**PLANNED UNIT DEVELOPMENT
& SUBDIVISION STAFF REPORT****Date: May 5, 2011****SUBDIVISION NAME**

Atlantis Subdivision

Planned Unit Development Approval to allow 15 apartment buildings (360 total units) and a club house on a single building site and Subdivision approval to create two legal lots from a legal lot of record.

SITE PLAN

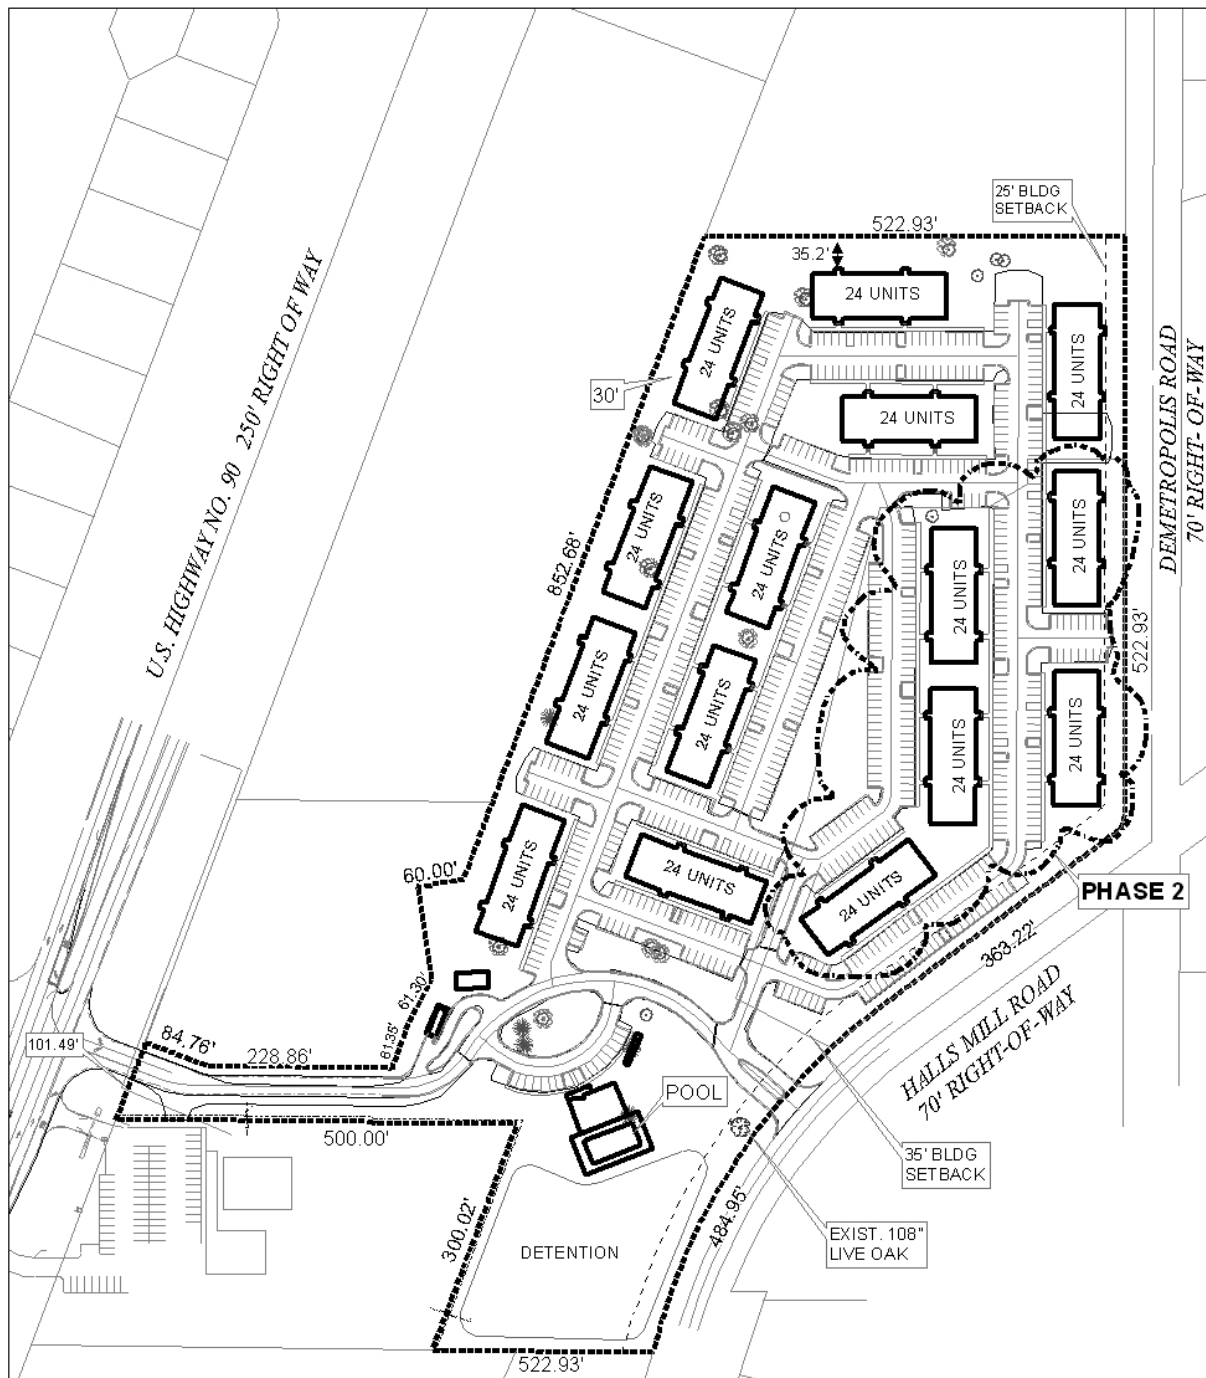
Regarding the site design, it appears that the building and parking layout meets the minimum requirements of the Zoning Ordinance. Staff cannot determine, however, if the site will comply with the tree and landscape requirements of the Zoning Ordinance, as no detailed information is provided other than a total area for open space: as a commercial site being developed for multi-family use, the site must fully comply with frontage, perimeter and parking tree requirements, as well as the total and frontage landscape area requirements of the Ordinance. As these items may result in the modification of the site plan, it is recommended that the applicant revise the plan to allow staff to verify that the site will meet the minimum requirements of the Zoning Ordinance.

The site plan does not depict sidewalks along any of the street frontages, however, sidewalks are required. The site plan should be revised to show sidewalks along all frontages of the proposed

The site plan was not revised to show TIS related improvements along Halls Mill Road or Demetropolis Road, however, a note was added stating that modifications would be made to accommodate the required roadway improvements.

The minimum building setback line is not depicted on the PUD site plan along US Highway 90, however it is shown on the Subdivision plat. The PUD site plan should be revised to also show minimum building setbacks from all adjacent public streets.

- 1) revision of the site plan to depicted the minimum building setback line from all street frontages, including US Highway 90;
- 2) compliance with Engineering comments (*It appears that connection to a City maintained drainage system is impractical without either acquiring a private drainage easement or a release agreement from the affected downstream property owner(s), unless it can be shown that the discharge from this site is designed such that it will comply with the revised storm water ordinance. Due to the existing topography, drainage from Lot 2 will be required to discharge onto Lot 1, therefore the proposed detention pond will either need to be sized to accommodate the detention required for Lot 2 or sized accordingly to receive the controlled discharge from Lot 2. The discharge from both Lots 1 & 2 shall be designed to provide at a minimum, detention from a 100 year storm with a 2 year release rate as outlined in the storm water ordinance. Any work performed in the right of way will require a right of way permit in addition to any required land disturbance permit.*);
